RE: A&M Project # 1873-03
MVRTA Newburyport
Intermodal Parking Facility
Peer Review Response Letter

Please accept Allen & Major Associates, Inc. (A&M) responses to Christiansen & Sergi, Inc.'s (CSI) comment letter dated October 16, 2017 regarding the proposed Intermodal Parking Facility. To facilitate the review, the CSI comments are reproduced below along with the A&M response in bold.

RE: A&M Project # 1873-03
MVRTA Newburyport –
Intermodal Parking Facility
Drainage Summary – Revision 1

DRAWING NO:
WS-1

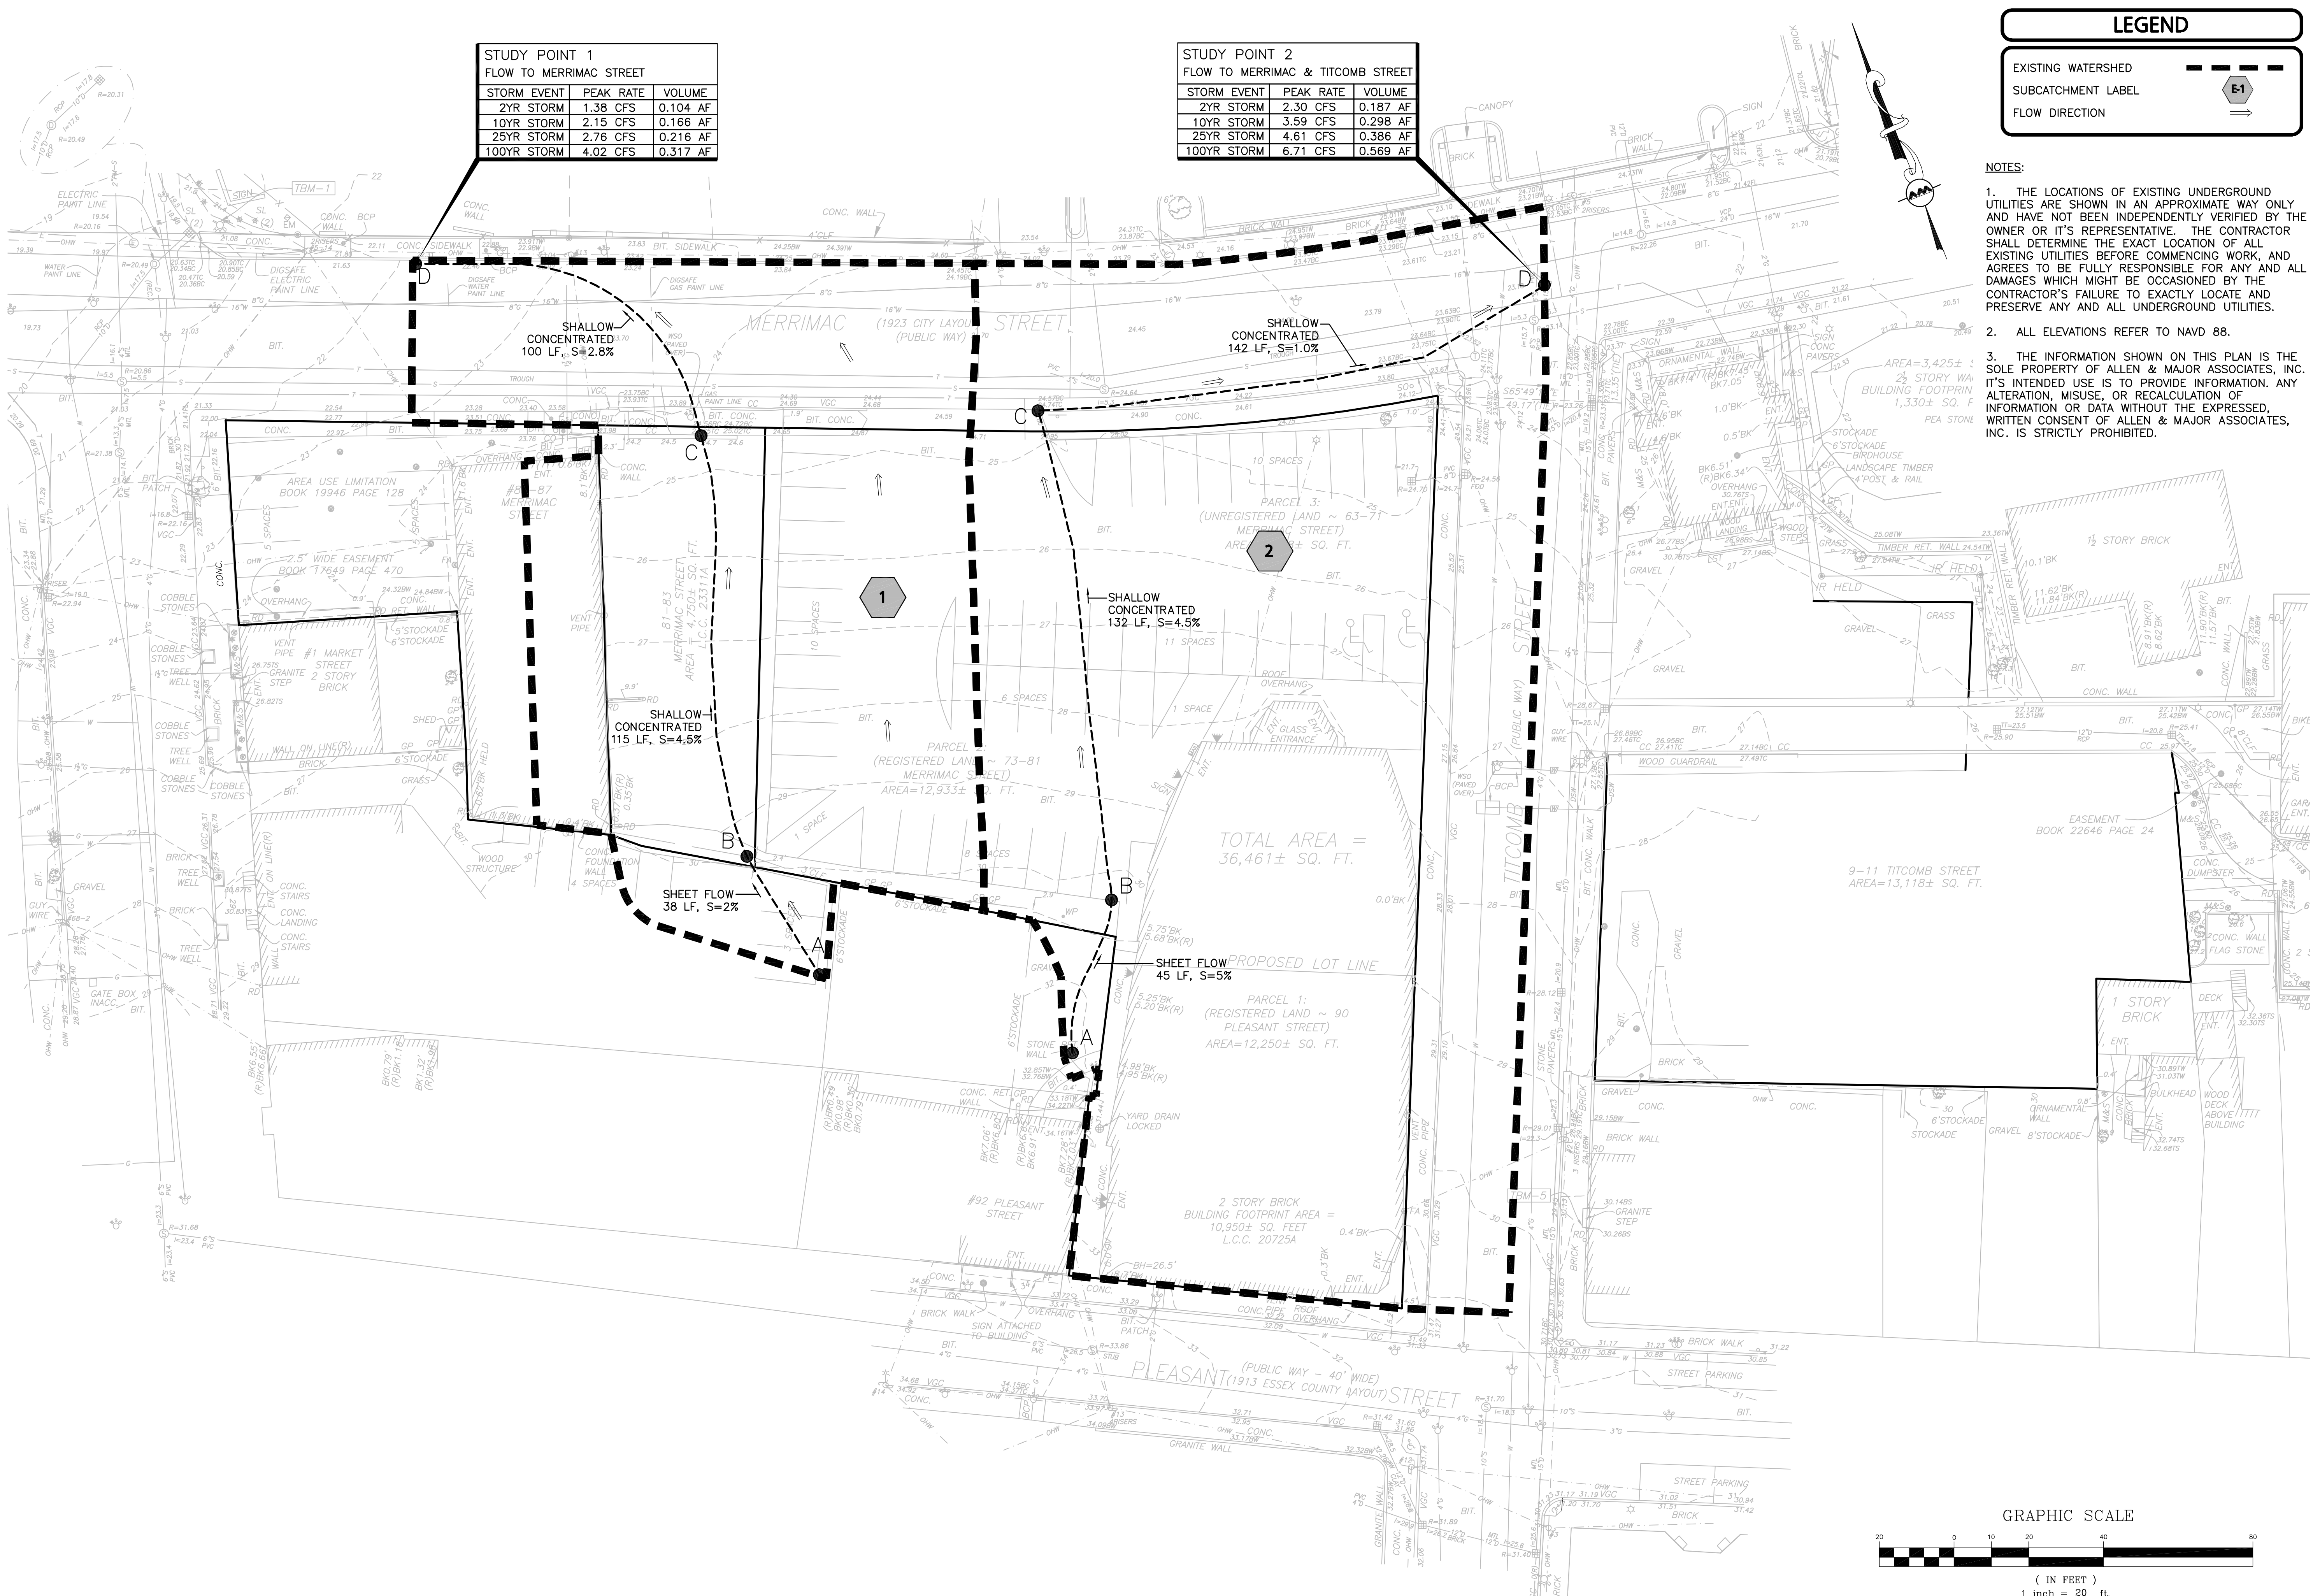
CSI Comment: The time of concentration for both the existing and proposed conditions was assumed to be 5 minutes. The volume of water generated by a storm from a piece of property is determined by the type of ground cover. The rate at which the water leaves a site is determined by the time of concentration. The shorter the time of concentration the greater the peak rate of flow the longer time of concentration leads to a more gradual flow rate. More accurate times of concentration should be calculated using the tools available in the HydroCAD program and the peak rates of flow recalculated with the new drainage areas.

A&M Response: *The time of concentration for both the existing and proposed conditions has been revised as requested. The travel paths have been added to the Watershed Maps (Sheets WS-1 and WS-2)*

DRAWING NO:
WS-2

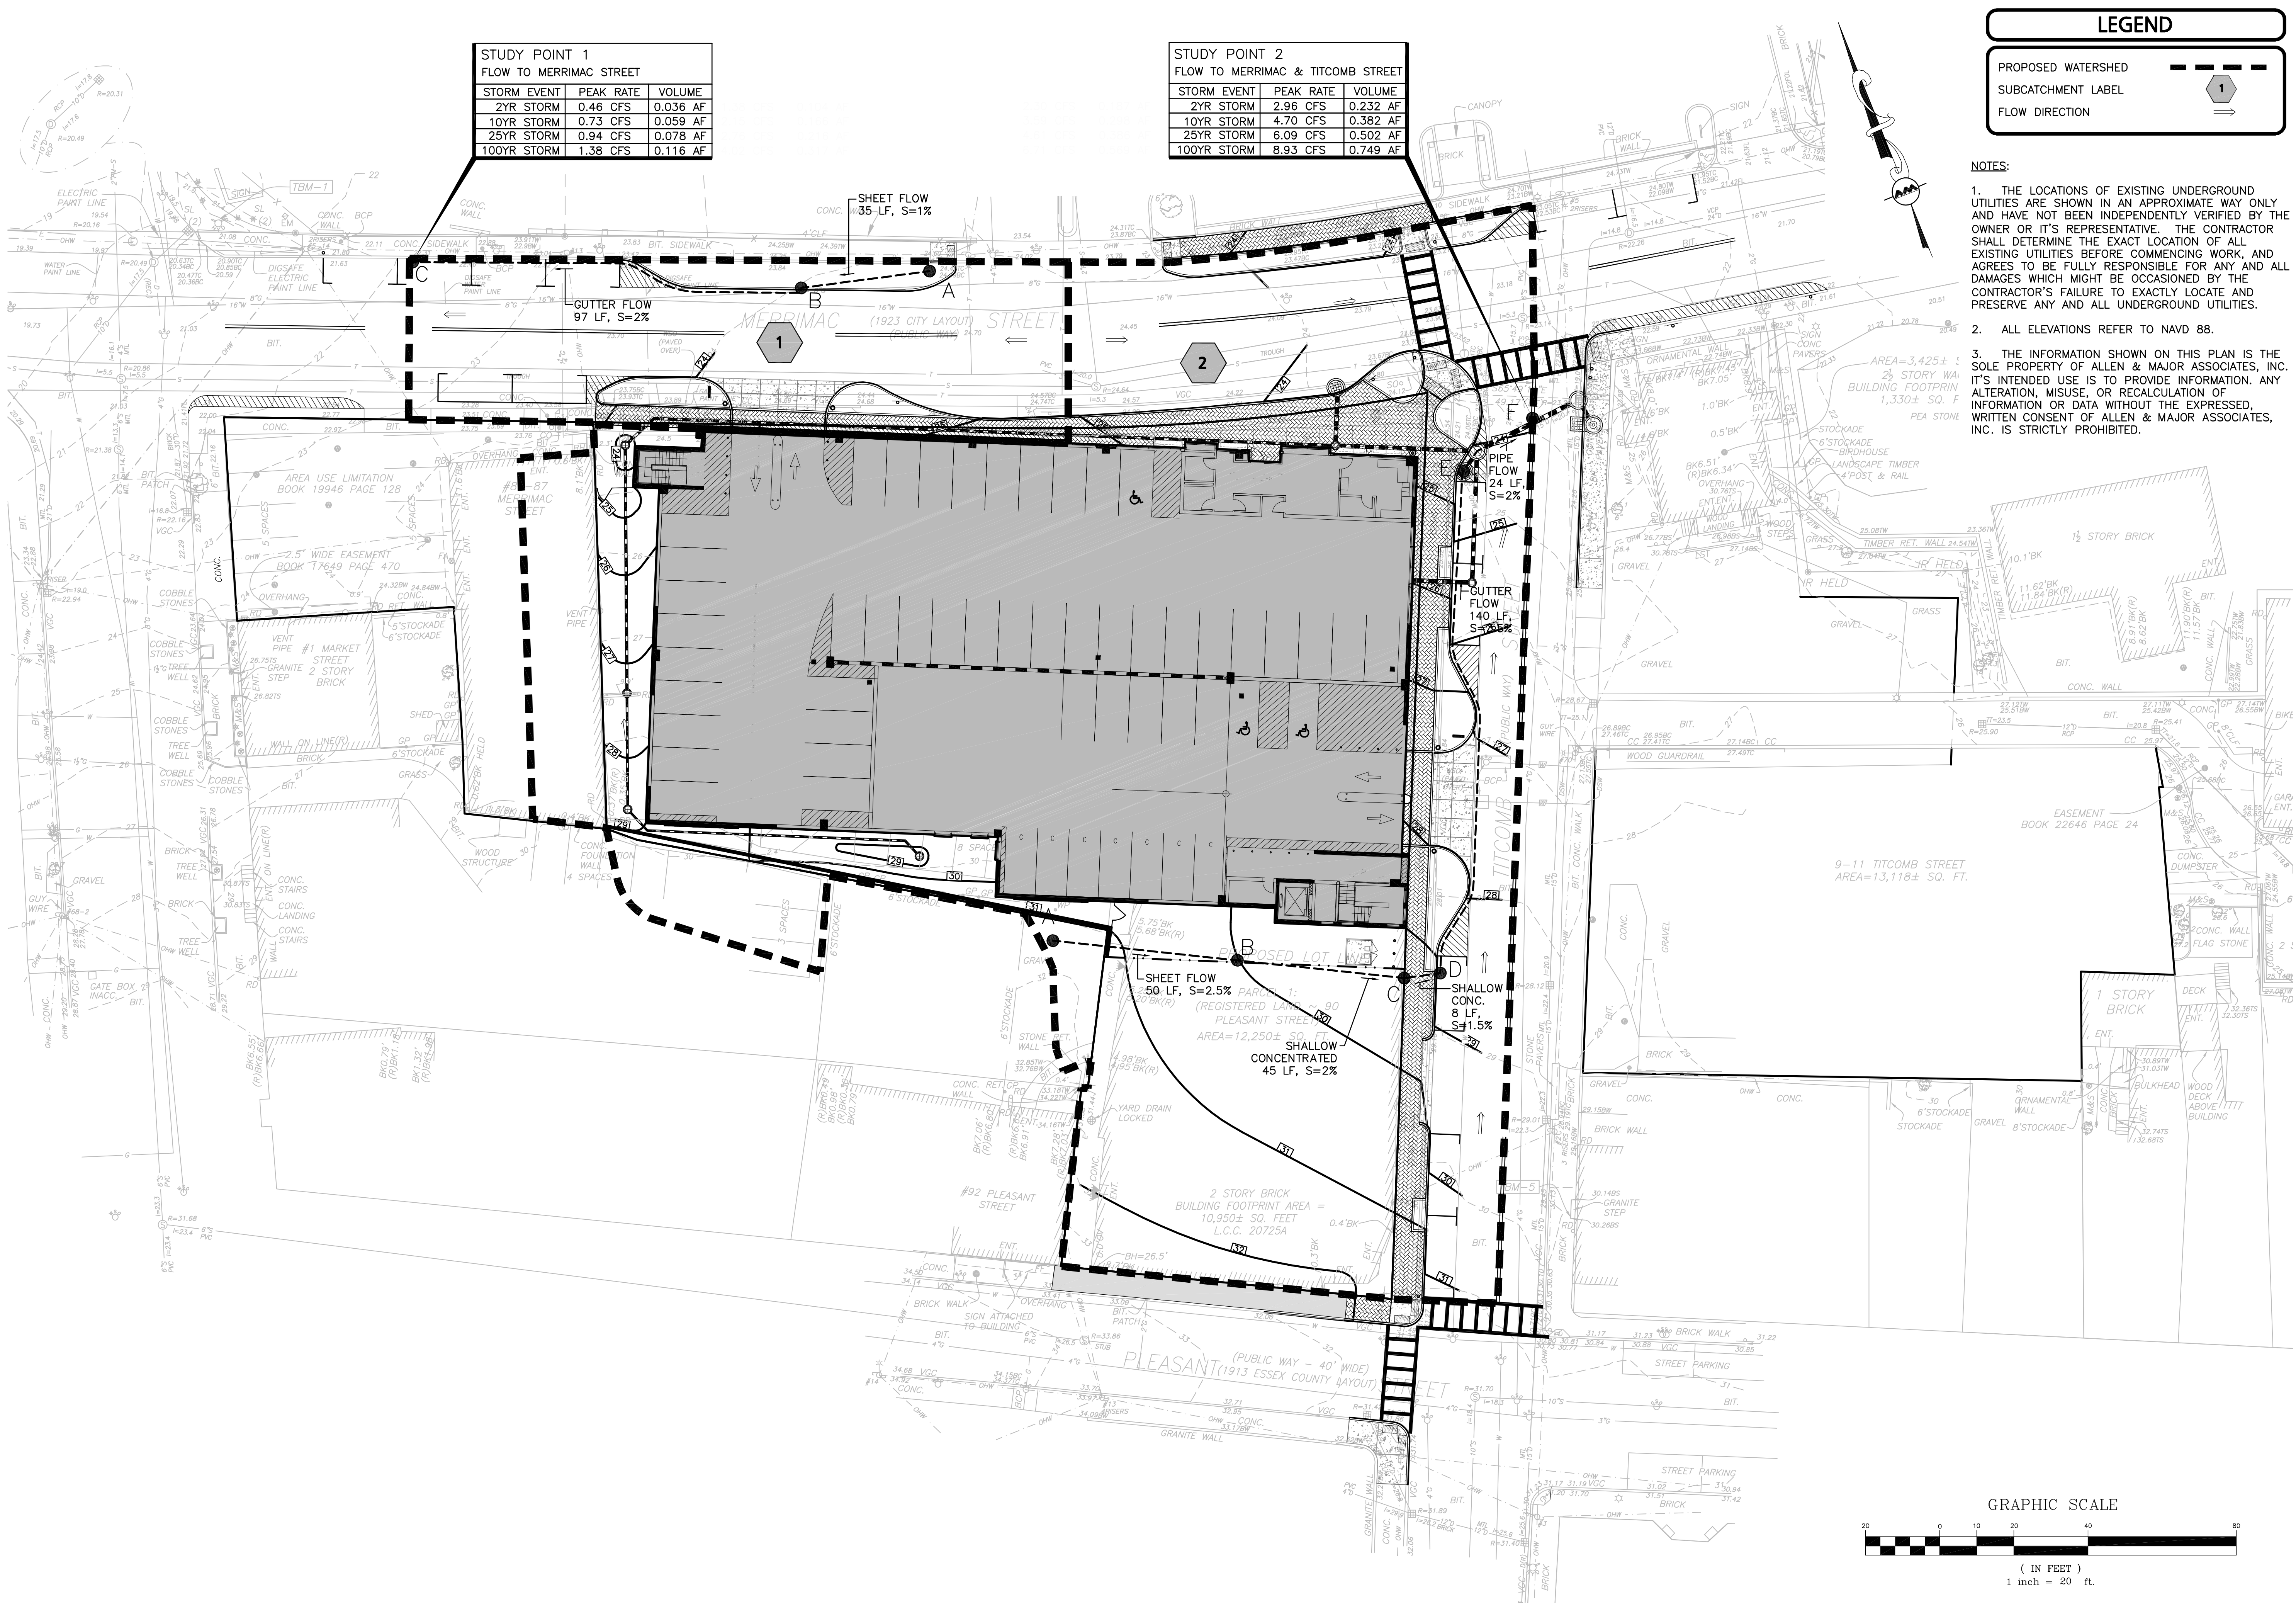
CSI Comment: On drawing WS-2 the Remaining Land Of New England Development is shown as undeveloped yet the drainage calculations show is as being developed. This should be clarified.

CSI Comment: The drainage areas outlined in the drainage plans do not take into account offsite drainage that enters the property under existing as well as proposed conditions. The downspouts from 85-87 Merrimac Street flow onto the property as well as flows from 92 Pleasant Street and the property of Market Street Trust which lie to the south. The flows from these properties will be intercepted by proposed area drains 1,2,3 and 4. The drainage area in the study should be expanded to include these additional areas.

A&M Response: *Once the existing building and pavement has been removed, the remaining land of New England Development will be compacted subgrade covered with crushed stone (See Sheet C-07 “Landscape Plan” and Sheet C-08 “Landscape Notes & Details”, Detail 5). The HydroCAD model has been revised to indicate that this area is “gravel” with a CN of 96.*

A&M Response: *The roof area and downspouts from 85-87 Merrimac Street (Pure Bliss) have been included to the watershed area. Only half of the roof area from this building enters the site. There are gutters and downspouts on both sides of the building. Regarding 92 Pleasant Street, based on a site inspection, we suggest that only a portion of this site flows onto the project area. There is a grass berm and solid wooden fence partially embedded along the rear lot line. We do agree that a portion of the Market Street Trust site flows onto the project area. The Watershed Maps and HydroCAD model have been revised to include this changes.*
